FREDERICK COUNTY PLANNING COMMISSION
October 10, 2018

TITLE: **Thackers Caskets**
Lot 2, Intercoastal Industrial Center

FILE NUMBER: **SP-02-21, AP#18644 (APFO#18646, FRO #18645)**

REQUEST: **Site Development Plan Approval**
The Applicant is requesting Site Plan approval to develop a 41,072 SF warehouse/ office on 3.56 acre site zoned Light Industrial (LI).

Exhibit 1: Rendered Site Plan

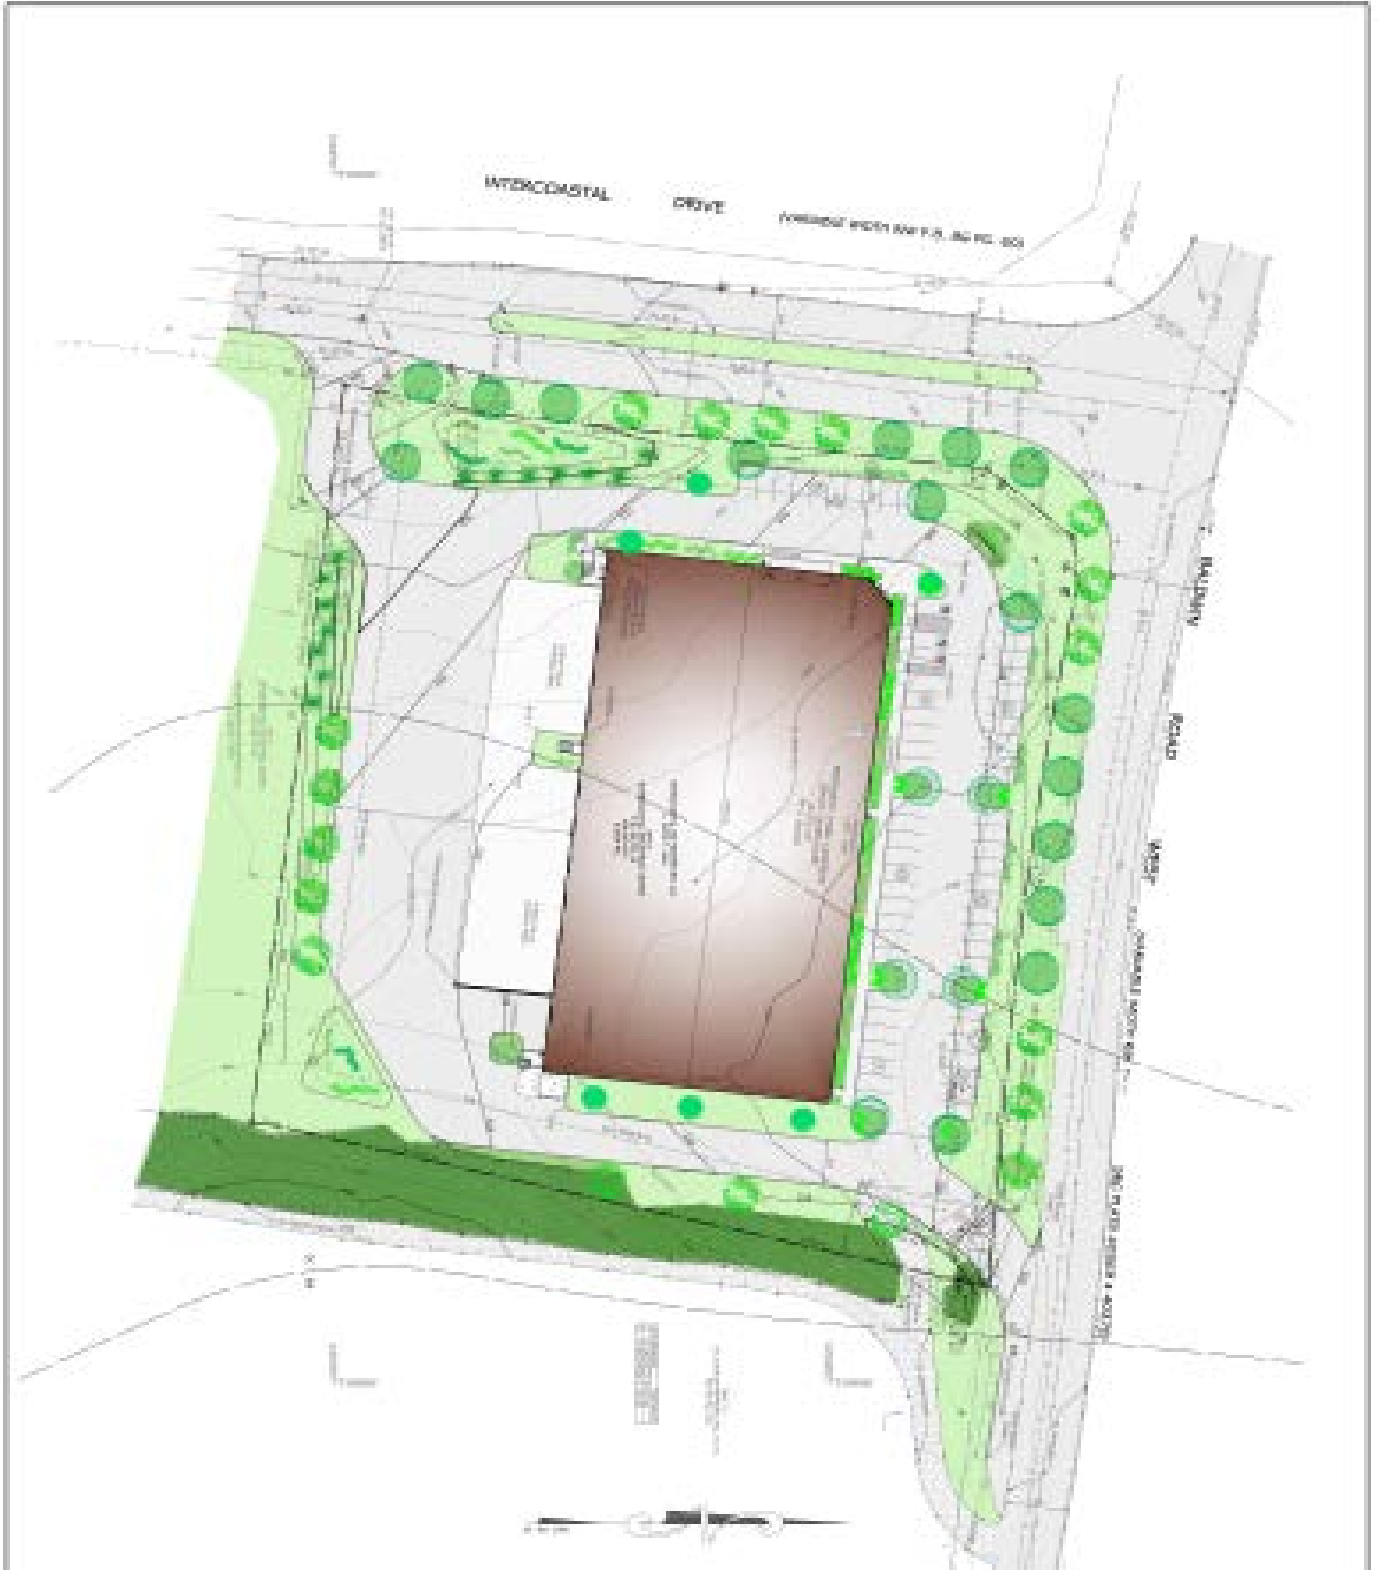
The proposed on-site landscaping is in conformance with the zoning requirements. Thirty-two (32) trees are planned and shrubbery is proposed along both building fronts and in the parking lot islands as required. The plantings are largely native but the proposed Serbian Spruce may need to be supplanted with a native species. The required 20% canopy coverage over the parking areas is exceeded, with 29% canopy coverage proposed.

Note E on the site plan accurately illustrates the parking required for the Site. The office use requires 28 parking spaces and the warehouse requires 33 parking spaces, for a total parking requirement of 61 spaces. The Applicant has provided 63 spaces. A modification to allow the extra two spaces has been submitted. Staff does not object to this minor adjustment.

5. **Loading §1-19-6.210.B:** For this 41,072 SF building, a minimum of 4 loading spaces are required. The Applicant proposes a total of 11 loading spaces to the rear of the building, four large trailer spaces and 7 smaller box truck spaces. Plan Note E2 states five trailer and eight box truck spaces. The note needs to be revised to reflect the condition shown on the plan.
6. **Bicycle Parking §1-19-6.220 (H):** In accordance with Z.O. § 1-19-6.220, one bike rack is required and one is provided.

1. Address all agency comments as the plan proceeds through to completion.
2. Adjust the evergreen species to provide some native evergreen plantings.
3. Revise Note E2 to reflect the number and size of loading spaces being provided.
